Errata to MPC8568E PowerQUICC III™ Integrated Processor Family Reference Manual, Rev. 1

This errata describes corrections to the *MPC8568E PowerQUICC III™ Integrated Processor Family Reference Manual*, Revision 1. For convenience, the section number and page number of the errata item in the reference manual are provided. Items in bold are new since the last revision of this document.

Figure 15-44. MII Mgmt Control Register Definition

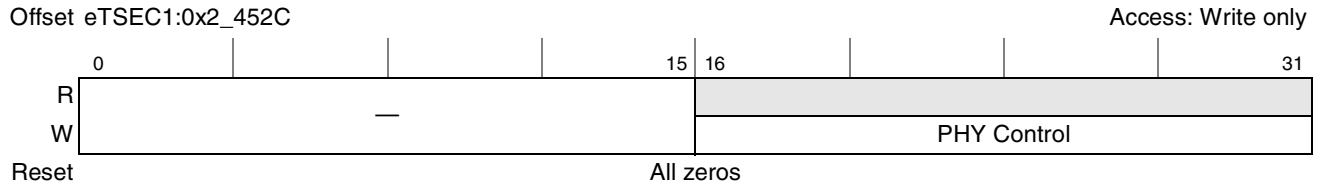
- 15.5.3.5.5, 15-73 In Table 15-43, “MAXFRM Descriptions,” modify the first paragraph of “Maximum Frame” (bits 16–31) field description, as follows:
 “This field is set to 0x0600 (1536 bytes) by default and always must be set to a value greater than or equal to 0x0040 (64 bytes), but not greater than 0x2580 (9600 bytes). It sets the maximum Ethernet frame size in both the transmit and receive directions. (Refer to MACCFG2[Huge Frame].) It does not affect the size of packets sent or received via the FIFO packet interface.
- 15.5.3.5.9, 15-75 Make Figure 15-44, “MII Mgmt Control Register Definition,” write only, as follows:

Figure 21-26. CE Interrupt Mux Control Register 0–3 (CEIMXCR0–CEIMXCR3)

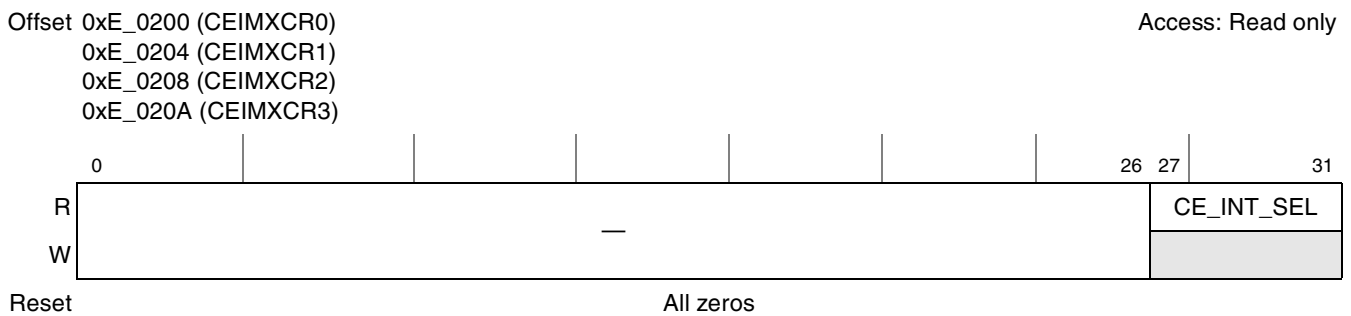
21.4.1.24, 21-29 Add Section 21.4.1.24, “CE Interrupt Mux Control Register 0–3 (CEIMXCR0–CEIMXCR3),” as follows:

This register programs the routing of the interrupt signals from hardware accelerators in the MPC8569E to the QUICC Engine EXT[1..4] SNUMs. Refer to External Hardware Request section of the RISC Control chapter in the *QUICC Engine Block Reference Manual with Protocol Interworking (QEIWRM)*. Interrupt signal connections can be routed either to the programmable interrupt controller (PIC) or to the QUICC Engine. By routing to the QUICC Engine, this allows it to handle the interrupts, and thus freeing up the CPU. Please contact Freescale for the availability of microcode packages taking advantage of this feature. Please note that the interrupt to the host CPU should be masked consistently with the programming of this register.

Figure 21-29. DDR Clock Disable Register (DDRCLKDR)

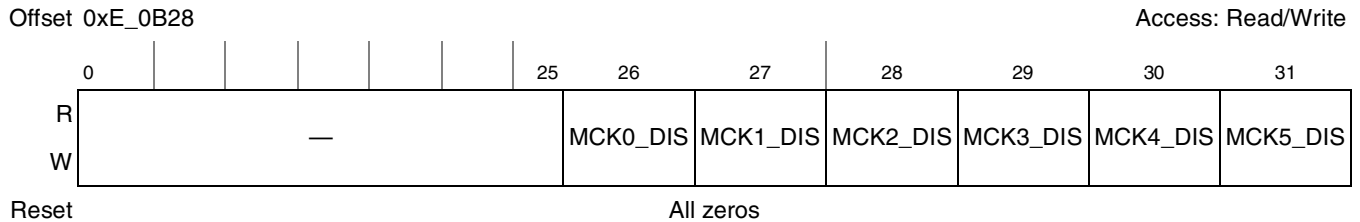
Shown in Figure 21-29, the DDRCLKDR contains bits that allow disabling the clocks of the DDR SDRAM controller.

Figure 21-32. SerDes Control Register 1 (SRDSCR1)

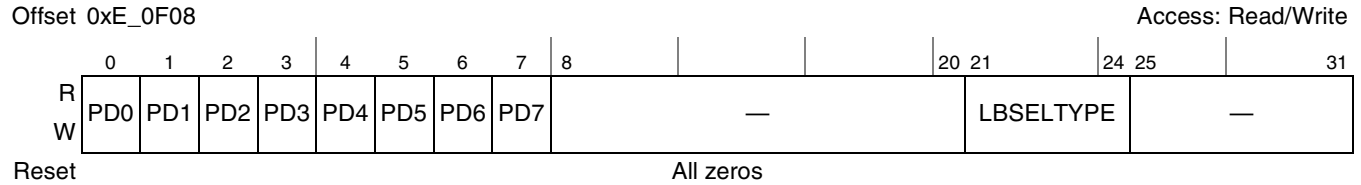
21.4.1, 21-33 Add Section 21.4.30, “SerDes Control Register 1 (SRDSCR1),” as follows:

Shown in [Figure 21-32](#), the SRDSCR1 contains the control bits for SerDes high-speed interface port.
